LANDMARK COMMISSION
REPORT

APPLICATION FOR EXTERIOR
RENOVATIONS TO
403 E. ADAMS STREET

Reference Number: LC-03-18

Date of Report: March 20th, 2018

PROPOSED PERIMETER FENCE - STAND HORSE - 40' ELEVATION

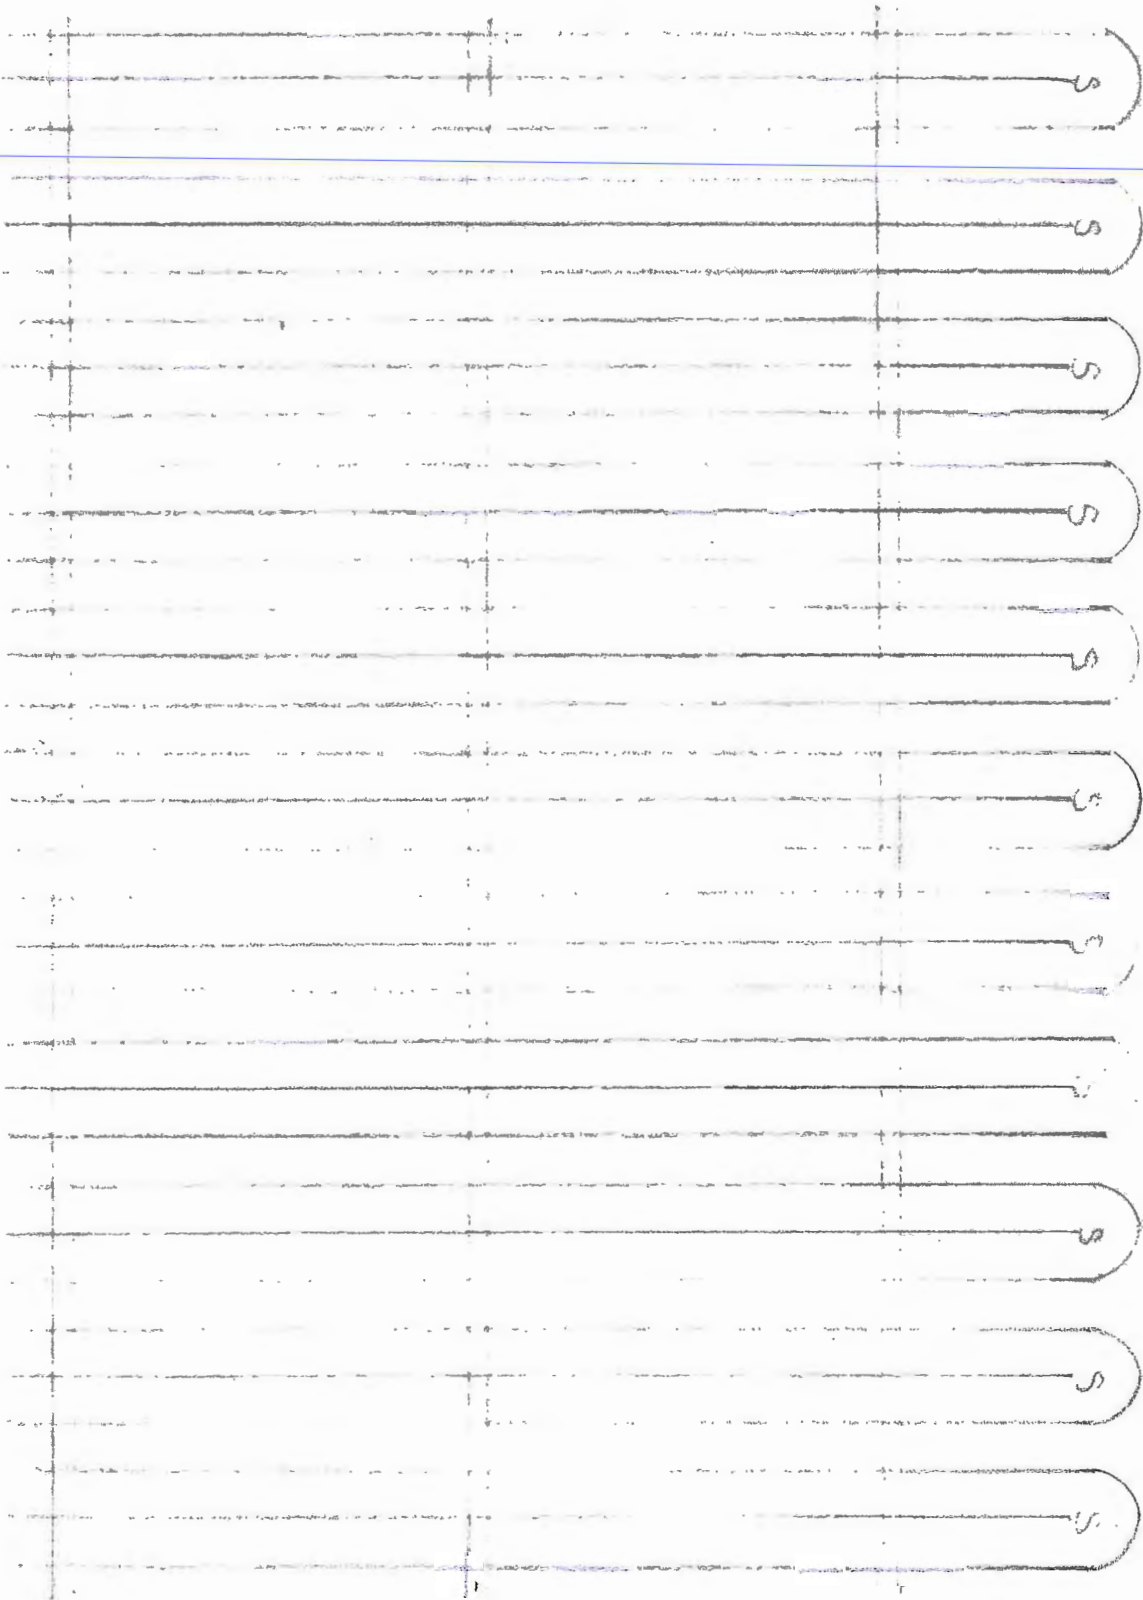
The applicant has provided a sketch of a 6' fence with openings that will contain a decorative feature. Staff has requested information from the applicant regarding what type of material the fence will be and a site plan indicating the proposed location. Staff will need to assure that the fence meets the zoning requirements in regards to height and location. The Design Guidelines state that traditional forms such as picket fence, plain board fences, and iron fencing in historic district are appropriate. Inappropriate styles would include chain link, stockade, shadow board, and other contemporary designs.
